TRIP REPORT

BASALT WASTE ISOLATION PROJECT

JULY 7 - 18, 1980

September 1980

STRUCTURES IN A BASALT UNIT

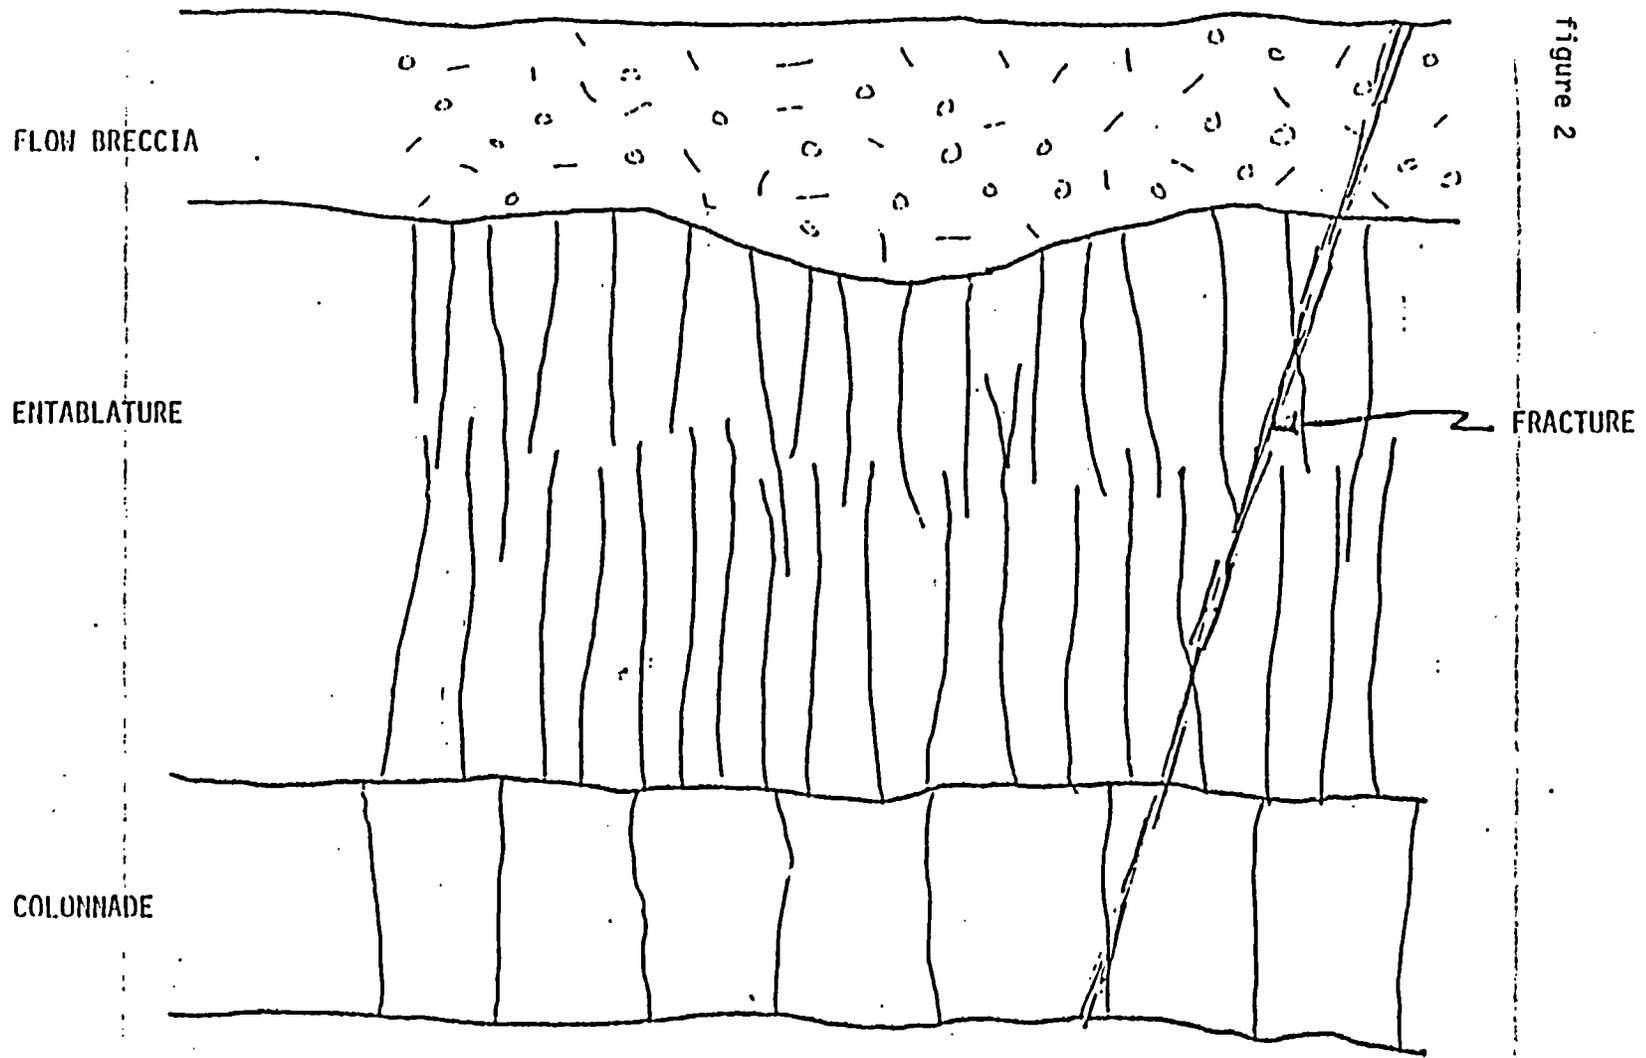
An important feature of a typical basalt flow is the marked contrast in permeability between the uppermost portion of the unit and the central and lowest portions (Figure 2). The upper portion, the "flow breccia zone," comprises up to 30 percent of total flow thickness and is characterized by vesicles (gas holes), breccia and rubble that formed by cracking and movement of the partly hardened crust as the lava moved. This rock is lower in density than average basalt, and the hydraulic conductivity is much higher (on the order of 10^3 times greater) than the hydraulic conductivity of the high density basalt below.
